June 30, 2015

File No.:VA101-70/16-A.01
Cont. No.:VA15-02703

Re: Blackdome Mine Tailings Storage Facility Assessment - Response to Memorandum Issued by Ministry of Energy and Mines to Blackdome-Sona Resources Corp. on February 3, 2015

Figure 2 Site Investigation Particle Size Distribution Summary

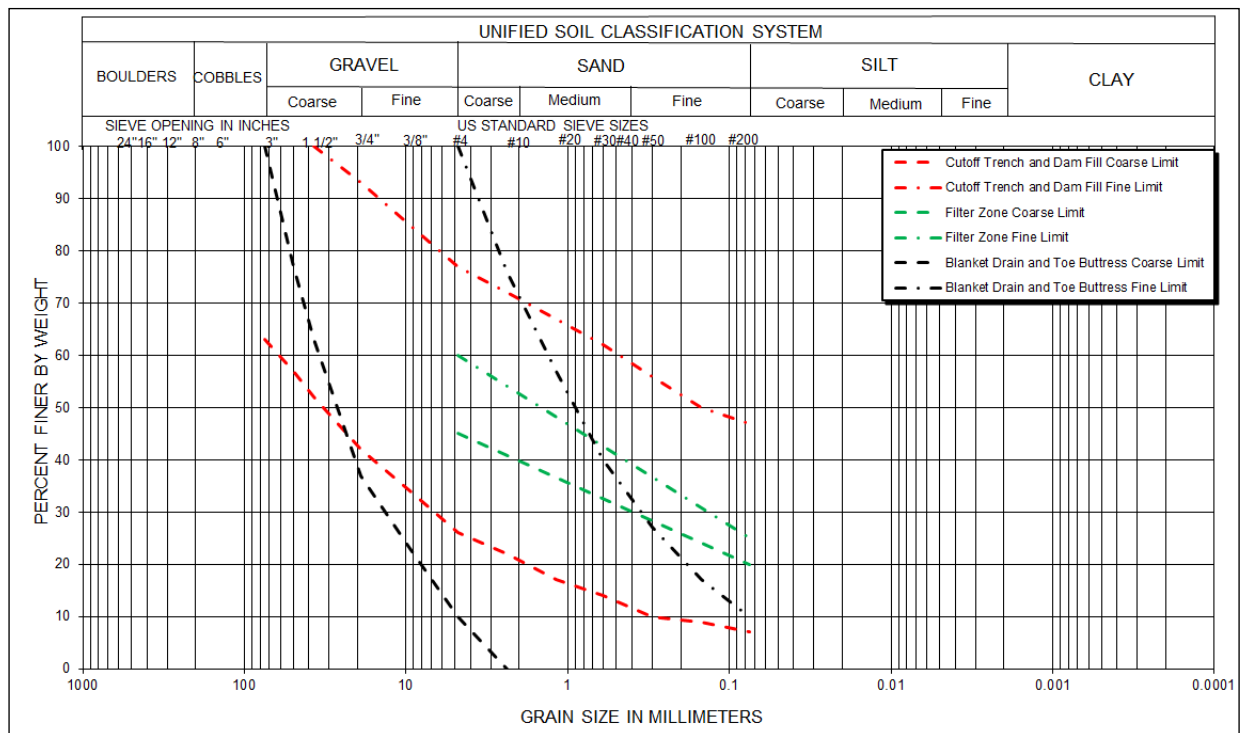
The summary of gradation analyses indicates the material is glacial till in origin, not glacio-lacustrine. The material can generally be classified as well graded gravel-sand-silt mixtures with more than 12% fines, where a glacio-lacustrine deposit would be poorly graded and predominately clay and silt based. The historical data indicates a foundation of well graded gravel-sand-silt mixture which is not considered silt and clay foundation.

Figure 4 TSF Embankment Cross Section

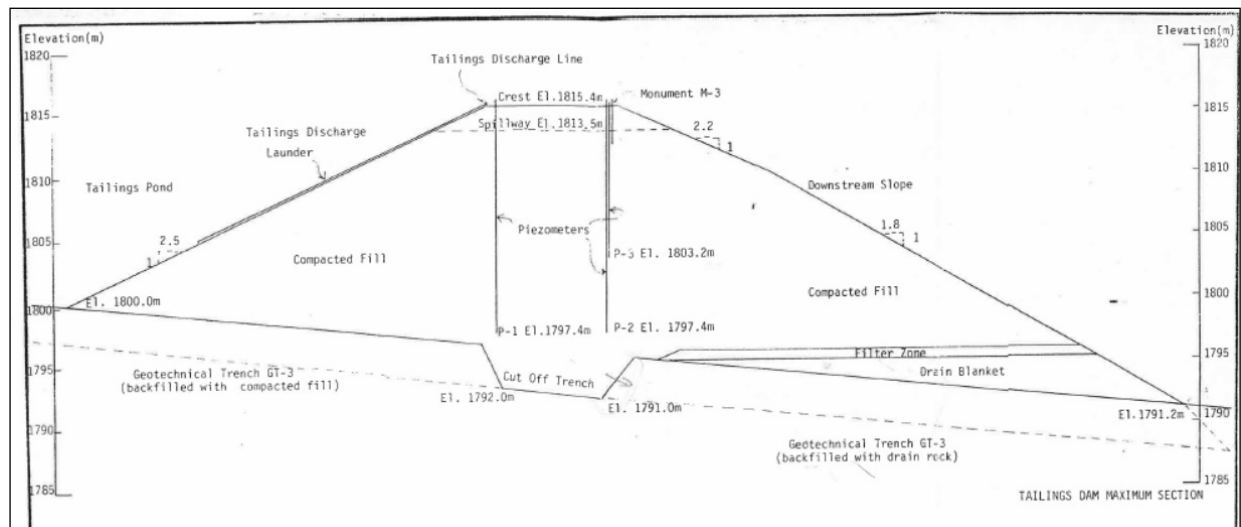
The original design of the Stage 1 TSF Embankment did not incorporate a filter zone, however during construction it was found that the drain blanket rock particles were near the coarser limit of the specified gradation range and the blanket drain was overlain by a filter zone of sandy and silty gravel originating from the mill bench strippings. The filter was constructed approximately 0.8 m thick to an elevation of 1,796 m as shown on Figure 4.

The assessment concluded the filter zone met the necessary filter criteria (D_{15max} is less than 0.7 mm for category two base soils with 40 to 85% passing #200 sieve after regrading). However, the filter did not meet the permeability criteria (D_{15min} is not greater than $4 \times d_{15}$ of the base soil or greater than 0.1 mm) and it is potentially gap graded (the ratio between the coarse and fine filter zone limits is greater than 5 for the material passing between 45 and 60% and the filter band has a coefficient of uniformity greater than 6). The assessment was not able to evaluate if the filter zone met minimum and maximum particle size or segregation criterion (relationship between D_{90} and D_{10}) with the data provided.

The assessment included evaluation of the blanket drain to act as a filter for the filter zone which concluded the blanket drain did meet the permeability criteria and filter band limits based on the Tailings Dam Construction Report. However, the blanket drain was found to not meet the necessary filter criteria and has the potential to be gap graded and could have segregated during construction.

The assessment concluded the filter zone met the necessary filter criteria. However, the filter did not meet the permeability criteria and it is potentially gap graded. The blanket drain was also found to not meet the necessary filter criteria and has the potential to be gap graded and could have segregated during construction.

The TSF will continue to be monitored during the Care and Maintenance period in accordance with the schedule outlined in the CDA guidelines. Annual inspections to date indicate the facility is functioning as designed. However, the site conditions must be re-evaluated prior to either resuming operations at the mine or shutting the mine down for closure.

FIGURE 13

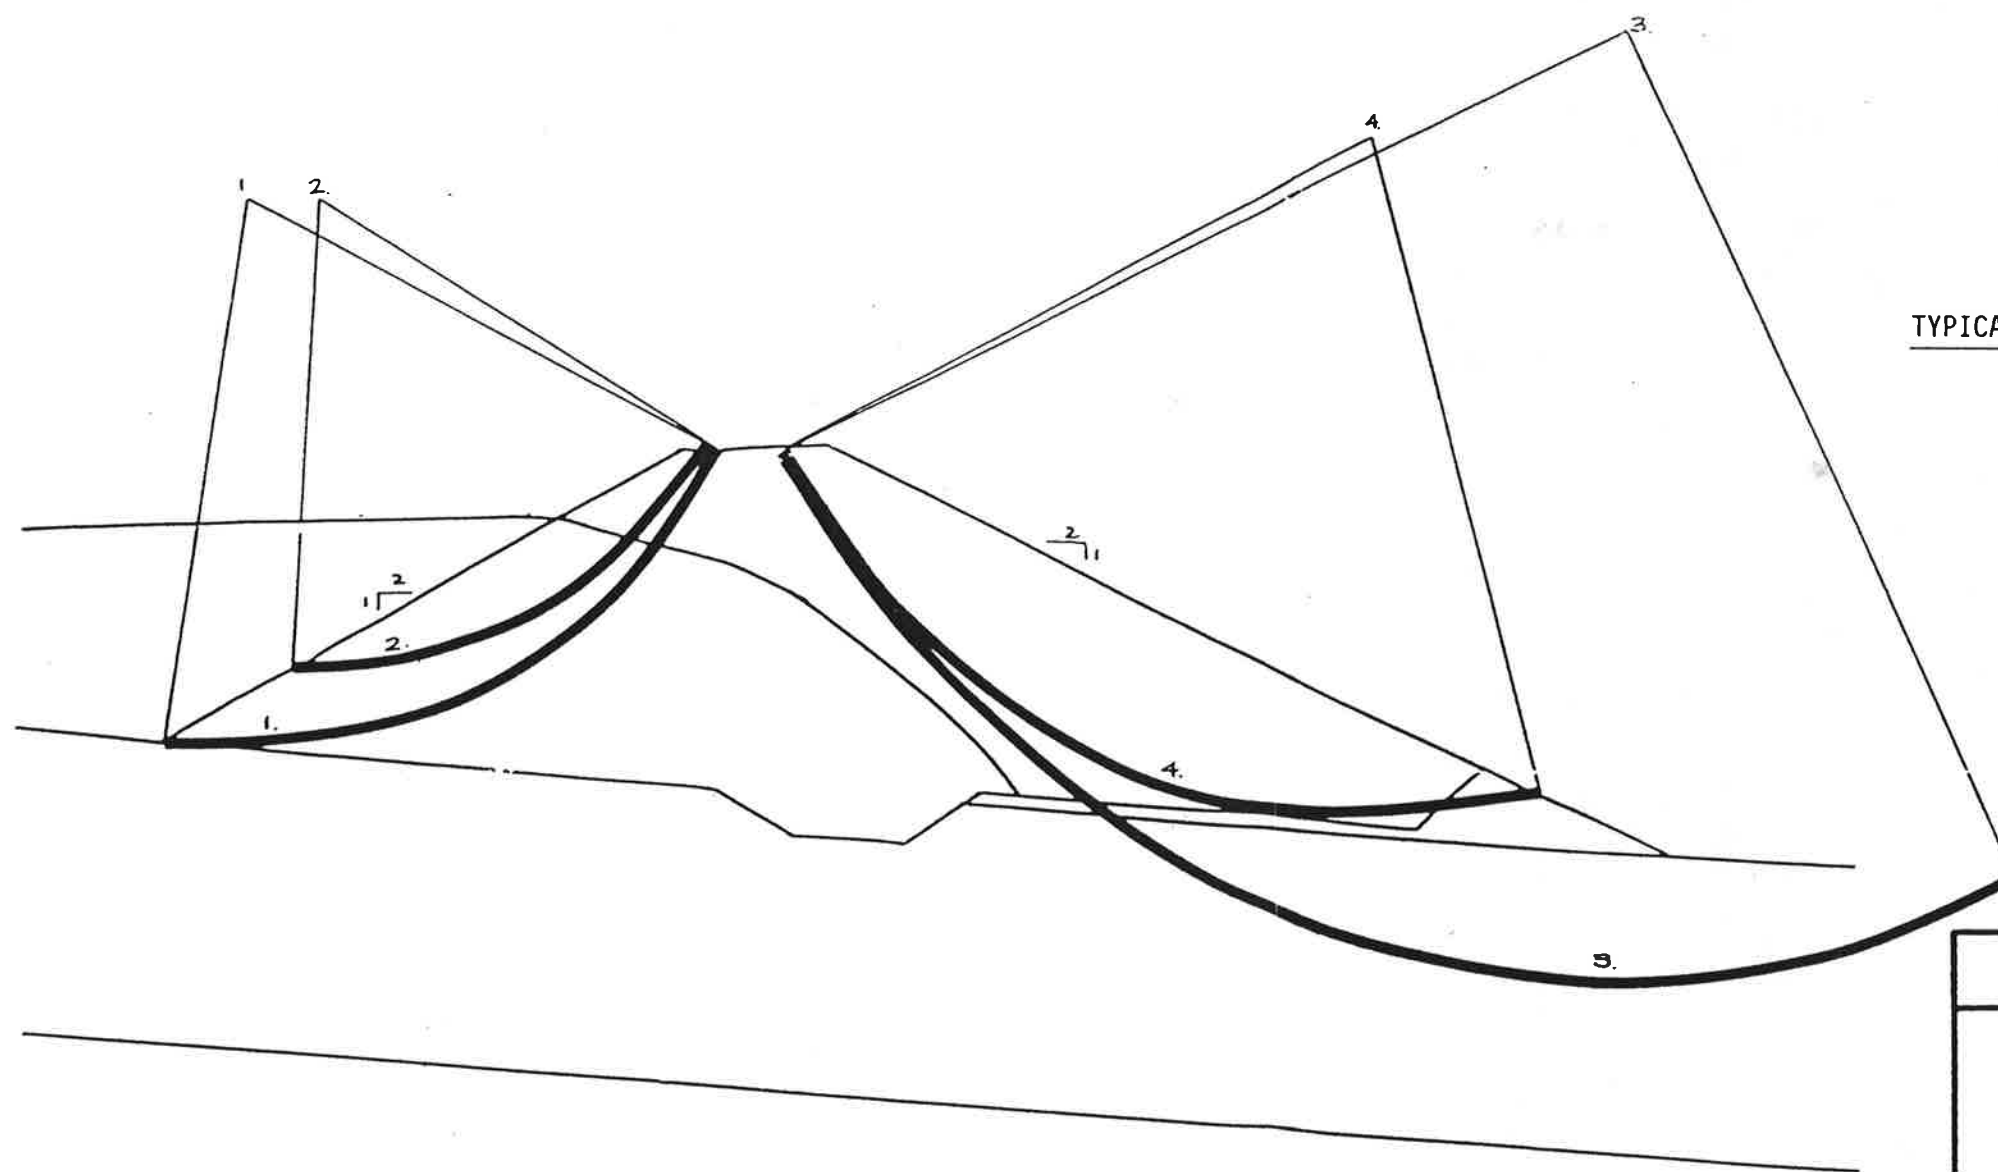
Figure 13 of the report has been included herein, showing the critical slip surfaces. In the report the slope designation for circles 3 and 4 were shown as upstream, whereas they were actually downstream. Please correct this in the report.

With these parameters the critical stability surfaces are similar to those presented in the report. The minimum factors of safety are:

<u>Loading Condition</u>	<u>Upstream Slope</u>	<u>Downstream Slope</u>
Static a = 0	2.63	1.62
Seismic a = 0.075 g	2.25	1.35

FIGURE A-6

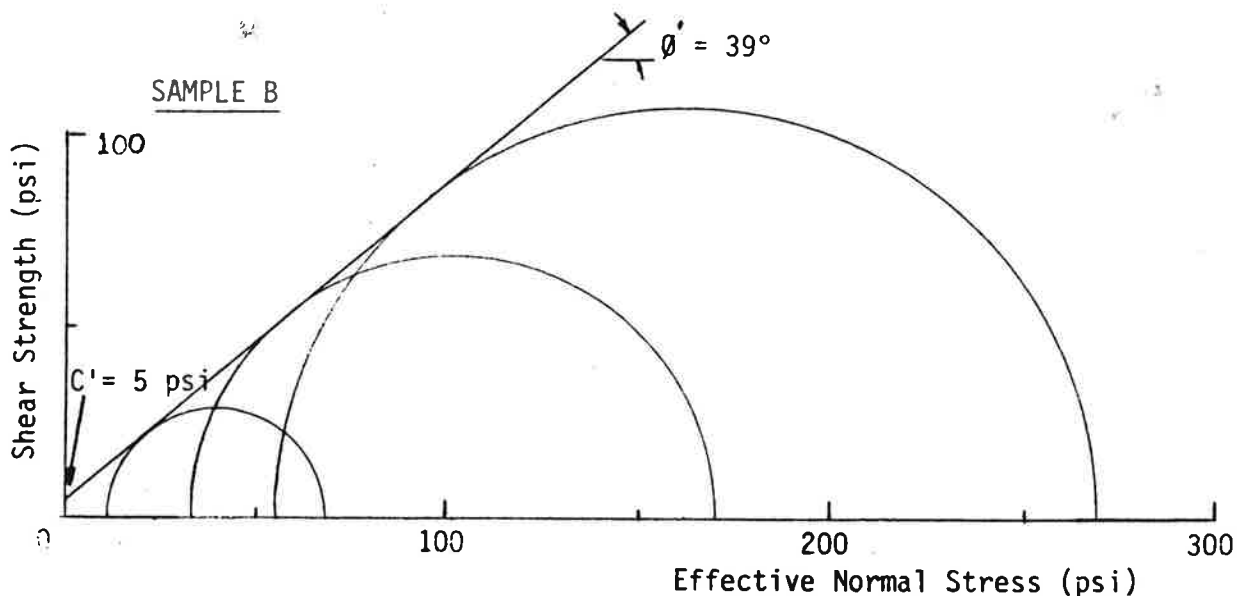
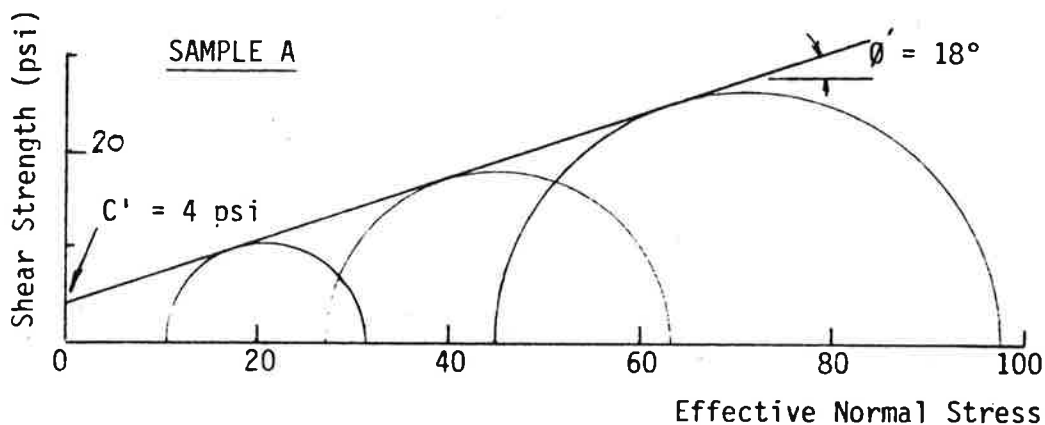
For these latest tests, two samples were prepared, at compaction levels of 94 and 92.5 percent. The first was tested at a confining pressure of 10.9 psi. The second was tested at a confining pressure of 31.6 psi, and prior to failure reconsolidated to 59.6 psi to provide a second Mohr's circle. The results of the tests indicated much higher strength values as shown below.

We consider the results of these most recent triaxial tests to be much more representative of the average strength of the materials to be placed for the dam for the following reasons:

However, we have reanalyzed the overall dam stability using a conservative assumption that 50 percent of the fill would be Sample A material at 86% compaction and 50 percent would be Sample B at 93.3% compaction. Therefore the stability impact parameters for the fill, as compared to our original report assumptions, average:
